**Proposed development: Prior Approval - Demolition (Regulation 4) for Demolition of single storey building with access to basement.**

**Site Address:  
Longshaw Nursery  
Crosby Road  
Blackburn  
BB2 3NF**

**Applicant: Blackburn With Darwen Borough Council**

Figure 3: Demolition Site Hazards Plan

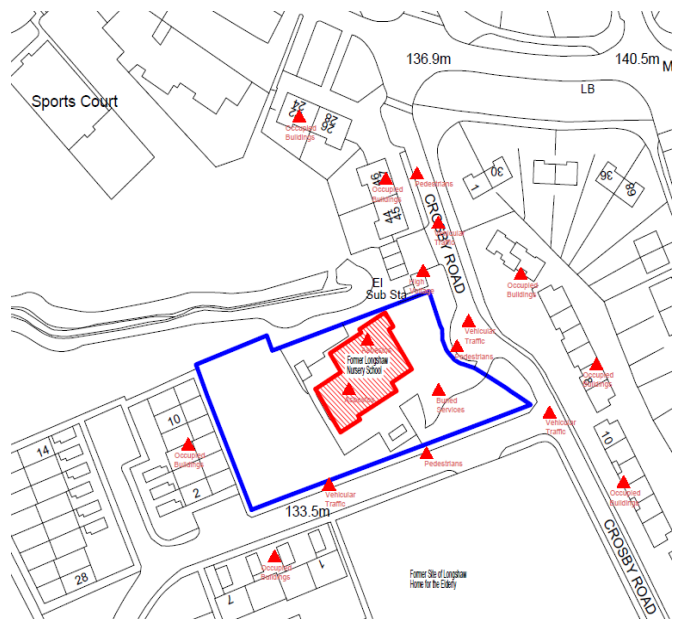
- 4.2.4 The Council's Highways Officer has reviewed the application and sought clarification on the location for the wheel wash facility. The agent has confirmed that following part demolition of the building to the eastern elevation the sites compound will be set up given the increased amount of space within the curtilage. The wheel wash facility will be provided in this location and will be appropriately drained within the site. The submitted site / swept path plan indicates the location of the operative parking which will be provide up to four parking bays near the stie access which was previously utilised for staff parking in-conjunction with the nursery, and this is considered acceptable. In addition, this aforementioned plan states that part of the south-eastern banking will be removed to allow for better manoeuvrability within the site for larger vehicles accessing, and once the demolition is completed the grass verge will be re-instated. For these reasons, the proposed works are not considered to lead to any significant disruption to the surrounding highway network.

The information received is representative of the works being applied for. However, the plan does not annotate how the internal site would be arranged and managed for wheel wash, parking of operatives etc, this should be received for assessment and approval.

- The location of the wheel wash is unknown, please provide further details. The wheel wash would need to be supported by a point where the dirty water is collected and removed from site, to ensure water does not flow onto the highway.
- We would not support any operative parking on Crosby Road, especially as this would hinder movement on what is already a restricted highway in width. Please highlight how the parking will be managed off street.
